From: Alice Pyper
Sent: 16 December 2020 11:44
To: 'Permitting Consultations'
Subject: RE: PAN-012213 Request for comments on deployment application

DAT File No 14895

Deployment Reference Number:	PAN-012213
Permit Reference Number:	EPR-AB3891CX
Permit Holder:	Stepside Agri
Site address:	Rhosygadair Fach, Tremain, Cardigan, Ceredigion, SA43 1RP
Grid reference:	SN 23253 50212

PRN 35714

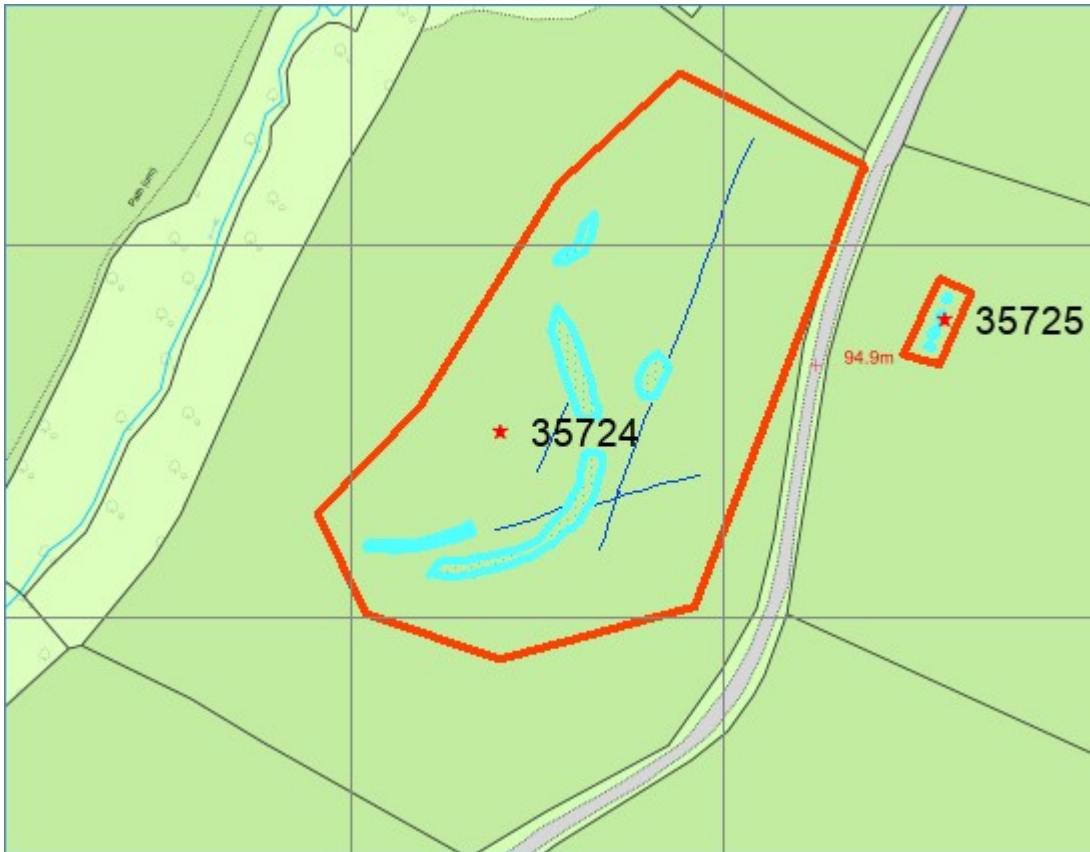
Having assessed the application, the proposals for land-spreading of waste should not have a detrimental impact on these features, which do not exhibit above-ground remains. However there may be archaeological deposits surviving below ground in those areas within the orange boundaries shown in the maps above, and we would recommend that these locations are not suitable for ground intrusive activities.
